UNITED STATES PATENT AND TRADEMARK OFFICE

APPLICATION NO.	FILING DATE	FIRST NAMED INVENTOR	ATTORNEY DOCKET NO.	CONFIRMATION NO.
10/716,925	11/19/2003	Paul Harrison	8204	6428

Office Action Summary	Application No.	Applicant(s)	
	10/716,925	HARRISON, PAUL	
	Examiner	Art Unit	
	Jeanne-Marguerite Goodwin	2841

DETAILED ACTION

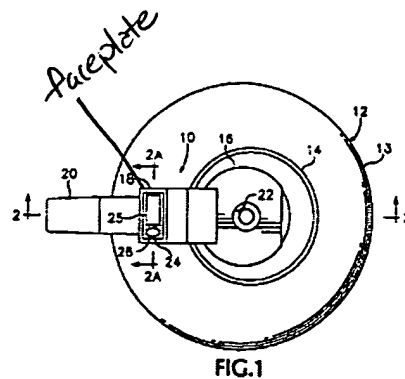
As per claim 4: Gallas discloses a command signal (27) being transmitted via a wireless communication link (light source/photodetector control system). Therefore, it would have been obvious to a person having ordinary skill in the art at the time the invention was made to add wireless communication link, as taught by Gallas, to the device of Johnson, in order to have an automatic concentration control system, as already suggested by Gallas.

As per claim 23: Furthermore, Johnson's device includes a faceplate (see figure below) for sound housing member, said faceplate inherently having openings in communication with said indicator devices, and said faceplate including markings associated with said indicator devices and the markings providing information related to the freshness state.
